**Rezoning Application:** PD 23-0918

**Development Services Department**

#### 1.0 APPLICATION SUMMARY

#### AGENCY REVIEW COMMENT SHEET

#### 2.4 Proposed Site Plan (partial provided below for size and orientation purposes. See Section 8.0 for full site plan)

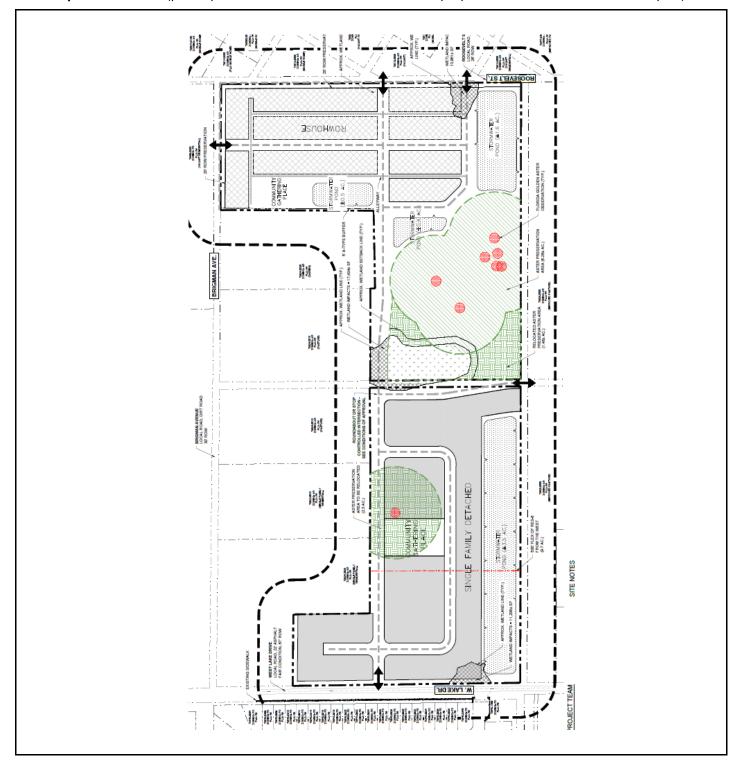
- 1. The PD site plan does not meet minimum requirements per the Development Review Procedures Manual (DRPM). For example:
  - A. The site plan does not adequately show the existing/planned additional right-of-way available along the project's Brigman Ave. frontage as was a requirement of the school district zoning for the parcel to the north (reference MM 21-1342).

- B. The site plan does not accurately show (or label) the right-of-way along the southern and eastern project boundaries.
  - C. The site plan does not accurately reflect the correct zoning designations of adjacent projects/parcels.

- D. The scale is not correct. Staff cannot review the project to determine whether certain aspects of the plan are compliant.
- 2. The applicant submitted a trip generation and site access analysis which does not match the development proposal and underestimates trip impacts. Accurate analysis is required by the DRPM and is necessary to provide the public with an accurate accounting of potential project impacts. The data and analysis is also used to determine whether site access improvements are warranted pursuant to Sec. 6.04.04.D of the LDC, as well as to determine the length of any required turn lanes.

- 3. While the applicant committed in the project narrative that Brigham Ave. (sic) and Roosevelt St. "adjacent to the site will be improved by the applicant including but not limited to dedicated Right-of-Way...", the applicant's roadway layout (on the PD site plan) does not show this to be the case. The site plan does not meet the requirements of LDC Sec. 3.23.08 which, among other things, requires that "Development must *provide* an interconnected network of publicly accessible streets, alleys or lanes...." (*emphasis added*). In the project sufficiency meeting and follow-up meetings we discussed a network that could be supported; however, this was not reflected in the applicant's proposal. If the applicant were to revise the site plan to match the narrative, that would be a supportable configuration.

- 6. The applicant is proposing a "roundabout or stop controlled intersection" at the intersection of the east/west and north/south roadways within the site; however, the geometry shown by the applicant did not draw a roundabout. Also, a roundabout would take up considerable extra right-of-way, resulting in additional wetland impacts which are not shown on the PD site plan. If the applicant desires to include a roundabout option, then the conceptual layout should show that option (desires to Transportation Technical Manual TD-4 (2) standards, as it has the greatest right-of-way needs and would require reconfiguration of the single-family development parcels and likely necessitate additional wetland impacts.

- 9. Applicant is proposing a rear loaded product type with a 0-foot front setback. It is unclear what Typical Section internal project roadways are proposed to be constructed to, although the Typical Lot Detail indicates a 50-foot section with no sidewalk strip (apparently indicating a TS-3 will be used). If a TS-3 typical section, a 0-foot setback would not be supported given the need for a 2-foot grass strip between the sidewalk and any fences, landscaping or other vertical

- 10. With respect to the rear alleys and based on the indicated pavement width of 10-feet, the applicant is proposing a one-way alley system. Driveways must be a minimum of 20-feet in length and are not permitted to encroach into the alley right-of-way for one-way alleys (since cars would otherwise hang into the travel way and block the narrow passageway, and/or would be unable to back out given insufficient room for backing movements given the proximity of other driveways in the driveway dense environment of an attached townhome project). The applicant must change driveway/setback graphics accordingly, and is encouraged to utilize two-way alley ways (16 feet of pavement within a 26 foot right-of-way in order to ensure proper backing movements). Alternatively, the applicant can propose alternative standards which address all of these concerns through the Design Exception process (provided they are not inconsistent with specified LDC requirements for alleyways as found in Sec. 3.23.08.F.).

- 11. The applicant has not provided a typical lot detail for those sections of the project where two-way alleyways are required. Staff notes that the location of one-way and two-way alleyways should be designated on the site plan for reference.

- 12. Please revise note 10, as it appears inconsistent with certain provisions of the Wimauma Downtown Overlay District. Roadway configuration of Roosevelt Rd. and Brigman Ave. can not be modified (and should not necessarily be considered internal). The east/west roadway similarly needs to run alongside the northern project boundary to allow opportunities for adjacent properties to complete the grid and make connections to the roadway in the future. If the east/west roadway is shifted south, then the applicant needs to dedicate additional lands between the roadway and northern property boundary in order to avoid creating a "spite strip". While some flexibility internally can be provided, the note needs to make clear the above-described parameters.

- 13. Please revise site plan note 11 to indicate whether always are intended be publicly maintained or will be privately with a public access easement (reference LDC Sec. 3.23.09.F.) Also, not all roadway segments may qualify for public maintenance, consistent with Policy 4.1.4 of the Mobility Element of the Hillsborough County Comprehensive Plan. Please revise the note to indicate, where a roadway does not qualify for dedication as a public roadway pursuant to the above referenced policy, then the roadway will be privately maintained (with a public access easement dedicated and conveyed to the County).
